Vermont Agency of Transportation
RECEIVED
CK'D BY HIS OK'D BY MRU
May 23, 2014
RESUBMIT NO Approved AsNoted
BY Carolyn Carlson DATE June 4, 2014

APPROVAL STAMP:	J.P. CARRARA & SONS INC. AL ST. ONGE CONTRACTORS, INC. Precast & Prestress Manufacturer 244 GEE ST., MONTGOMERY, VERMONT 05751 Phone: (802)388-6361 Fax: (802)388-9910
STATE OF VERMONT AGENCY OF TRANSPORTATION COUNTY OF FRANKLIN	DATE: MARCH 10, 2014 SCALE: NOTED
TOWN OF MONTGOMERY ROUTE NO. TH 10 CLASS 3 BRIDGE NO.: 36 PROJECT NO.: BHO 1448 (27)	CHKD: - DFTM: T.D. JOB NO: 23421-014
P/C SLEEPER SLAB DETAILS	DWG. NO: SLS-1

B REINFORCING SECTION
SLS-1
3/4" = 1'-0"

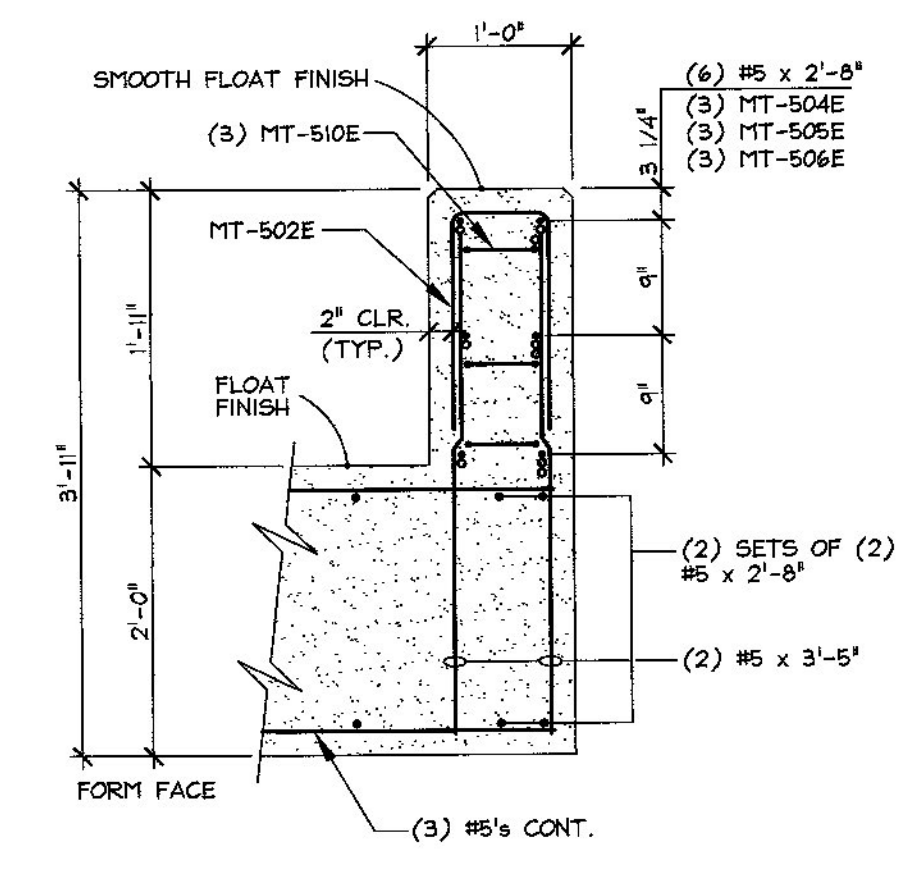
if 3" clearance on this leg also, then will need to narrow up these stirrups also. currently I believe there is 2 11/16" clear on each side for MT-510E and 2" for MT-502E

C REINFORCING PLAN DETAIL
SLS-1
3/4" = 1'-0"

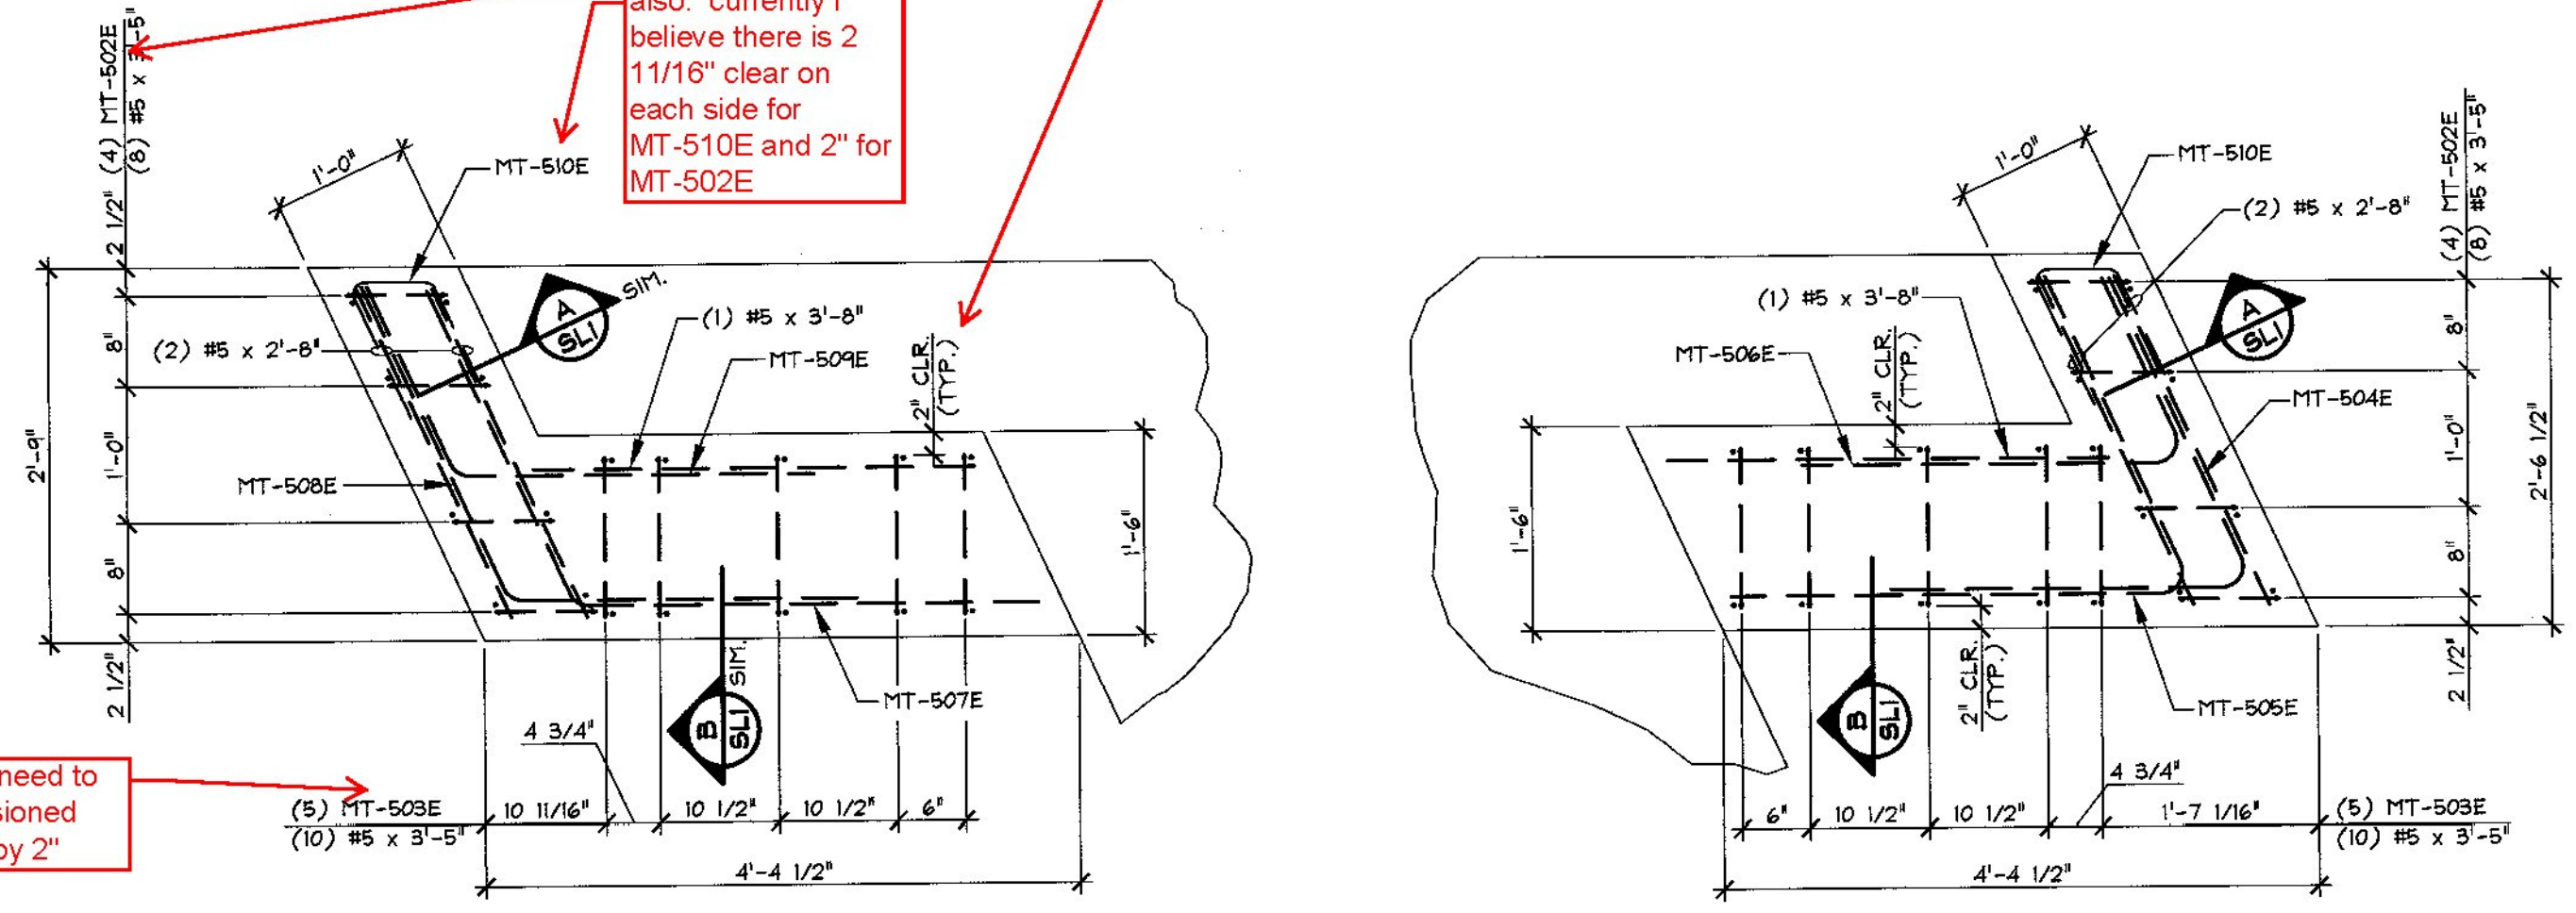
these will need to be dimensioned narrower by 2"
